MILITARY SPECIFICATION

CONNECTORS, ELECTRICAL, RECTANGULAR, CRIMP CONTACT

This amendment forms a part of Military Specification MIL-C-81659B, dated 2 August 1976, and is mandatory for use by all Departments and Agencies of the Department of Defense.

Figure 4, Dimensional changes in upper view as shown:

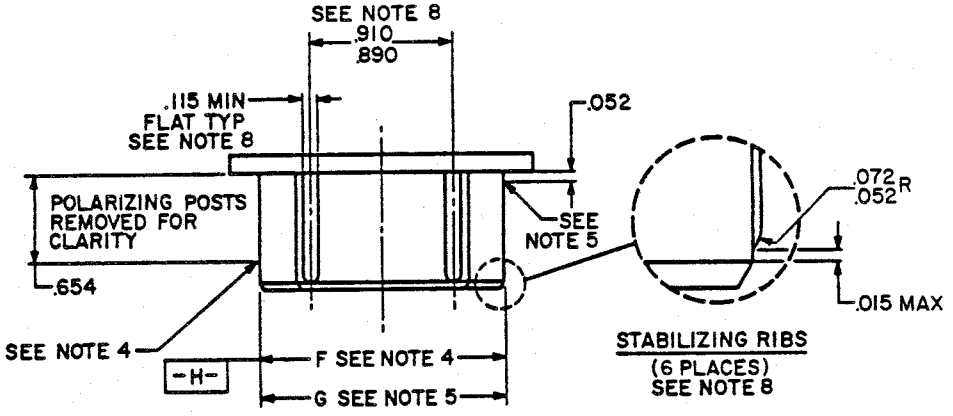
1. Table, Column D, insert "MIN" and delete dimension ".996 (25.30)."

2. Table, Column F, insert "MIN" and delete dimension "1.616 (41.05)."

3. Note 4, delete ".102/.098 from front edge"; insert ".654 from flange."

4. Note 5, delete "/.048."

Figure 5, Dimensional changes in upper view as shown:

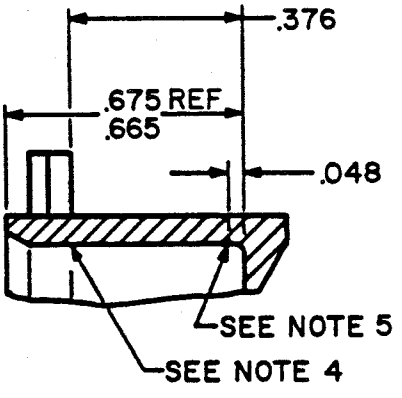
1. Table, column D, insert "MIN" and delete dimension "1.004 (25.50)."
2. Table, column E, insert "MAX" and delete dimension "1.003 (25.48)."
3. Table, column F, insert "MIN" and delete dimension "1.624 (41.25)."
4. Table, column G, insert "MAX" and delete dimension "1.623 (41.22)."
5. Note 4, delete ".302/.298 from top edge"; insert ".376 from bottom of cavity."
6. Note 5, delete ".052/."

Figure 6, Dimensional changes in upper view as shown:

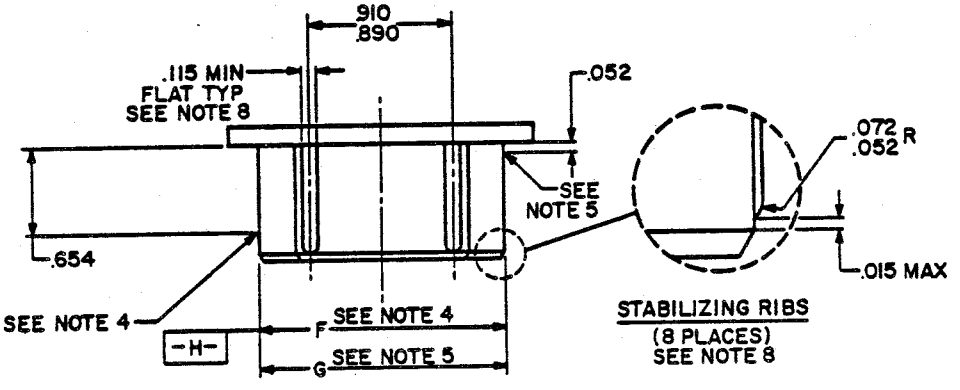
1. Table, column D, insert "MIN" and delete dimension "2.339 (59.41)."
2. Table, column F, insert "MIN" and delete dimension "1.621 (41.17)."
3. Note 4, delete ".102/.098 from top edge"; insert ".654 from flange."
4. Note 5, delete "/.048."

Figure 1, Dimensional changes in upper view as shown:

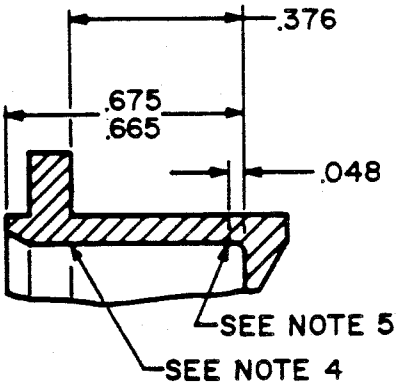
1. Table, column D, insert "MIN" and delete dimension "2.347 (59.61)."
2. Table, column E, insert "MAX" and delete dimension "2.346 (59.59)."
3. Table, column F, insert "MIN" and delete dimension "1.629 (41.38)."
4. Table, column G, insert "MAX" and delete dimension "1.628 (41.35)."
5. Note 4, delete ".302/.298 from top edge"; insert ".376 from bottom of cavity."
6. Note 5, delete ".052/."

Figure 8, Dimensional changes in upper view as shown:

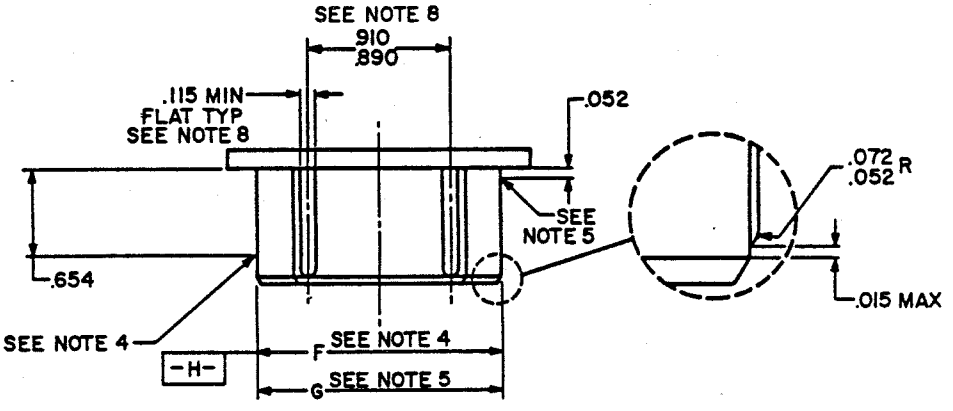
1. Table, column D, insert "MIN" and delete dimension "3.589 (91.16)."
2. Table, column F, insert "MIN" and delete dimension "1.621 (41.17)."
3. Note 4, delete ".102/.098 from top edge"; insert ".654 from flange."
4. Note 5, delete "/.048."

Figure 9, Dimensional changes in upper view as shown:

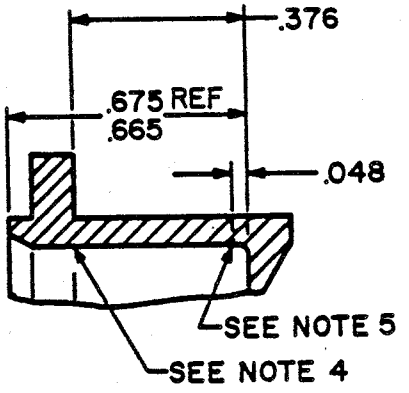
1. Table, column D, insert "MIN" and delete dimension "3.595 (91.31)."
2. Table, column E, insert "MAX" and delete dimension "3.590 (91.19)."
3. Table, column F, insert "MIN" and delete dimension "1.629 (41.38)."
4. Table, column G, insert "MAX" and delete dimension "1.628 (41.35)."
5. Note 4, delete ".302/.298 from top edge"; insert ".376 from bottom of cavity."
6. Note 5, delete ".052/."

Figure 10, Dimensional changes in upper view as shown:

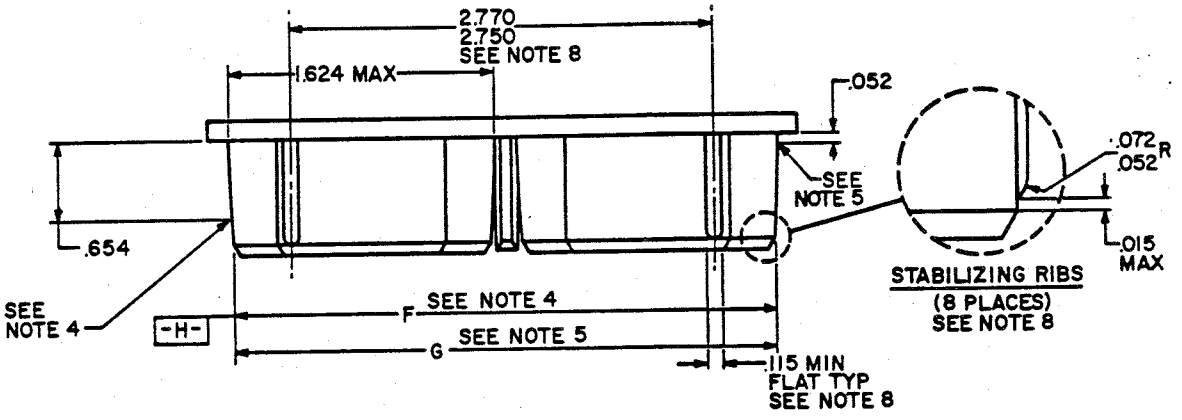
1. Table, column D, insert "MIN" and delete dimension "2.345 (59.56)."

2. Table, column F, insert "MIN" and delete dimension "3.492 (88.70)."

3. Note 4, delete ".102/.098 from top of edge"; insert ".654 from flange."

4. Note 5, delete "/.048."

Figure 11, Dimensional changes in upper view as shown:

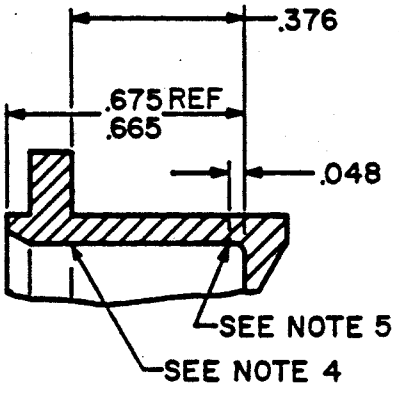
1. Table, column D, insert "MIN" and delete dimension "2.351 (59.72)."
2. Table, column E, insert "MAX" and delete dimension "2.350 (59.69)."
3. Table, column F, insert "MIN" and delete dimension "3.498 (88.85)."
4. Table, column G, insert "MAX" and delete dimension "3.497 (88.82)."
5. Note 4, delete ".302/.298 from top edge"; insert ".376 from bottom of cavity."
6. Note 5, delete ".052/."
